COUNCIL ASSESSMENT REPORT

Panel Reference	PPSSCC – 596
DA Number	DA-24-00789
LGA	Blacktown
Proposed Development	Demolition, tree removal and construction of a new school with capacity for 870 students including car parking, internal roads and associated civil and landscaping works
Street Address	Lot 11 DP 17048, 63 Townson Road, Schofields
Applicant/Owner	Al-Faisal College Limited
Date of DA lodgement	13 August 2024
Number of Submissions	55
Recommendation	Refuse, based on the grounds listed in the report.
Regional Development Criteria - Schedule 6 of SEPP (Planning Systems) 2021	Private infrastructure and community facilities valued over \$5 million (estimated development cost \$17,707,283)
List of all relevant s4.15(1)(a) matters	• Environmental Planning and Assessment Act 1979 • Biodiversity Conservation Act 2016 • State Environmental Planning Policy (Biodiversity and Conservation) 2021 • State Environmental Planning Policy (Industry and Employment) 2021 • State Environmental Planning Policy (Planning Systems) 2021 • State Environmental Planning Policy (Resilience and Hazards) 2021 • State Environmental Planning Policy (Sustainable Buildings) 2022 • State Environmental Planning

Extract 1: Civil Engineering Package, DWG. DAC01.15, Rev. 04, dated 17.04.2025

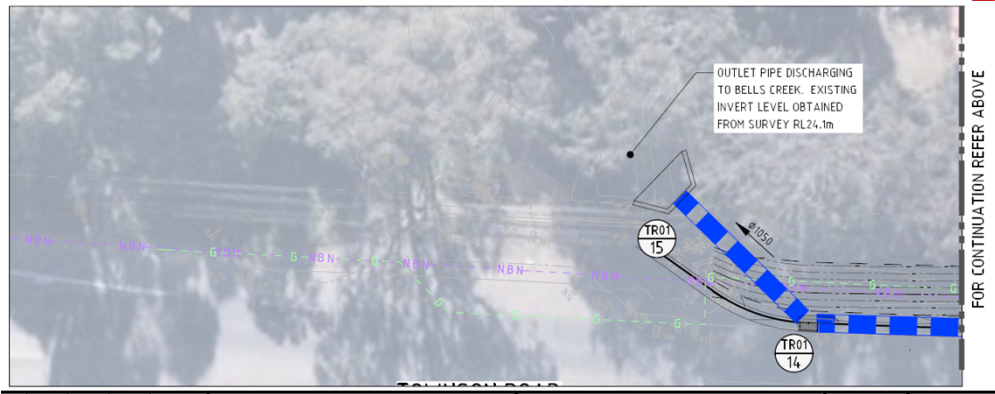
- 8.1.1 The applicant proposes engineering works including a headwall outlet to allow for the stormwater from the site to drain into Bells Creek on Lot 43 DP 1175138, 9 Townson Road, Schofields. The applicant has not provided owners consent for these engineering works in accordance with 23(1) of the Environmental Planning and Assessment Regulation 2021.
- 8.1.2 Extract 1 below identifies the engineering works which show them as extending west down Townson Road to this downstream property.
- 8.1.3 Extract 2 shows the works that are proposed within Townson Road reserve. The applicant has not acknowledged works on this land in the Statement of Environmental Effects but they are shown only on the Engineering drawings.

Extract 2: Civil Engineering Package, DWG. DAC05.07, Rev. 03, dated 17.04.2025 - including the legend.

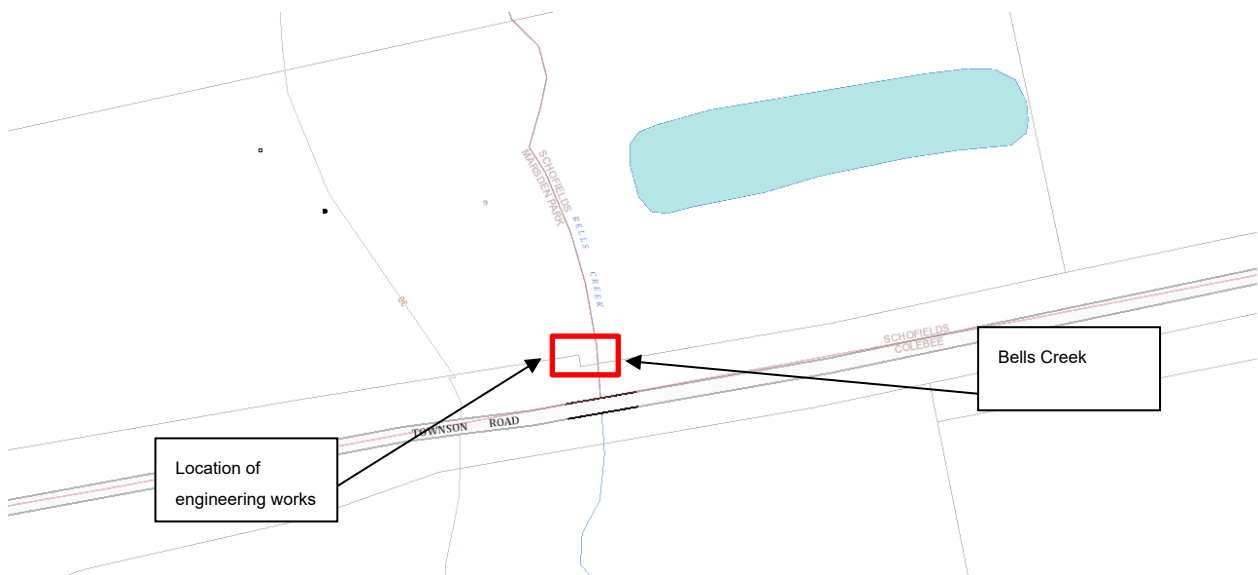
- 8.1.4 Extract 2 below provides the details of the engineering works proposed on Lot 43 DP 1175138, 9 Townson Road, Marsden Park
